Service Bulletin

Bulletin No.: 22-NA-009

Subject: Information on New Torque Specification and Installation Procedure for ACDelco Spin-On Oil Filters

5951260

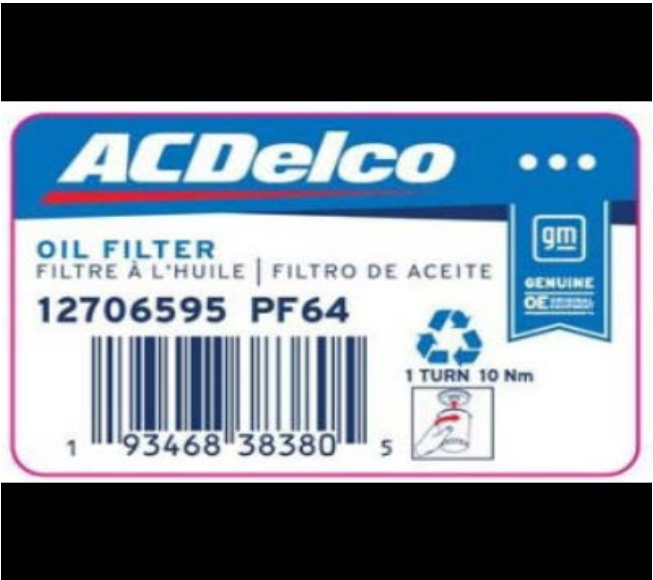
Involved Region or Country	North America, Europe, Uzbekistan, Russia, Middle East, Iraq, Israel, Palestine, Argentina, Brazil, Bolivia, Chile, Colombia, Ecuador, Paraguay, Peru, Uruguay, Venezuela, Japan, Cadillac Korea (South Korea), GM Korea Company, China, Taiwan, Thailand, Singapore, Philippines, Australia/New Zealand, Egypt, Other Africa, South Africa
Condition	Some customers or dealers may comment on an oil leak coming from underneath the front of the vehicle after a prior oil service was performed. This leak can take several thousand miles to occur.
Cause	This may be caused by an oil leak coming from between the oil filter gasket and mounting surface. – Technicians may also notice that the filter is very easy to remove and can sometimes be removed by hand.
Information	<p>To correct this condition, engineering has released a revised installation specification for all Spin-on oil filters. The new specification will be as follows:</p> <ol style="list-style-type: none"> 1. Lubricate the NEW oil filter gasket with clean engine oil. 2. Install Oil Filter 1 full turn after gasket makes contact with the sealing surface on the filter mounting flange. If installing with a torque wrench, this should be approximately 10 N•m of torque. <p>This installation specification will be updated in Service Information (SI) and the label on the oil filters (example shown below) will be updated as well.</p>
